Access Compliance Report

Public Rights-of-Way

(Curb Ramps)

Intersection ID: 27595	Main Street: BALLANTYNE COMMONS PY	Cross Street: BALLANTYNE MEADOWS DR	Location: SW
ADA ID: 8BE60407A95B	Ramp Type: Directional1	Initial Pass/Fail: Fail	Overall Compliance: No
Severity Score: 12.5			
Codes/Mitigation Info/Possible Solution		Field Measurements/Component Compliance

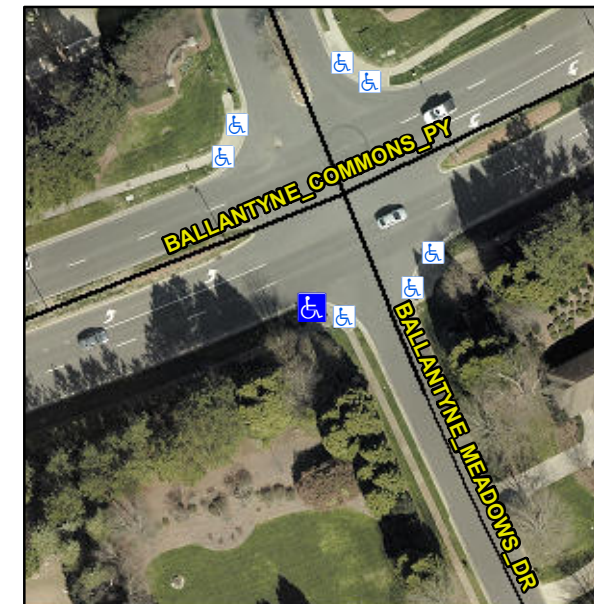
R304.2.2

Compliance	Description	Data	Compliance	Description	Data
N/A	Ramp Length (in)	80.0	N/A	Grade Break?	N/A
Yes	Ramp Width (in)	63.0	N/A	Grade Break Slope (%)	0.0
No	Ramp Slope (%)	10.4	N/A	Grade Break XSlope (%)	0.0
Yes	Ramp XSlope (%)	0.9			
N/A	Flare Type LT	N/A	N/A	Flare Type RT	N/A
N/A	Flare Slope LT (%)	N/A	N/A	Flare Slope RT (%)	0.0
N/A	Flare Traversable LT?	N/A	N/A	Flare Traversable RT?	N/A
N/A	Landing Length (in)	0.0	N/A	DWS Provided?	N/A
N/A	Landing Width (in)	0.0	N/A	DWS Contrast?	N/A
N/A	Landing Slope (%)	0.0	N/A	DWS Length (in)	N/A
N/A	Landing X Slope (%)	0.0	N/A	DWS Full Width?	N/A
N/A	Landing Curb? (Y/N)	N/A	N/A	DWS Offset LT (in)	N/A
N/A	Shared Landing?	N/A	N/A	DWS Offset RT (in)	N/A
N/A	Gutter Ponding?	0.0	N/A	Gutter Slope (%)	N/A
N/A	Gutter Lip Ht (in)	0.0	N/A	Gutter X Slope (%)	N/A
N/A	Painted X Walk1?	No		Road Slope (%)	4.7
	X Walk 1 Direction	To NW		Road X Slope (%)	4.2
	X Walk 1 Width (in)	N/A		Clear Space?	N/A

Remove & Replace Entire Ramp.
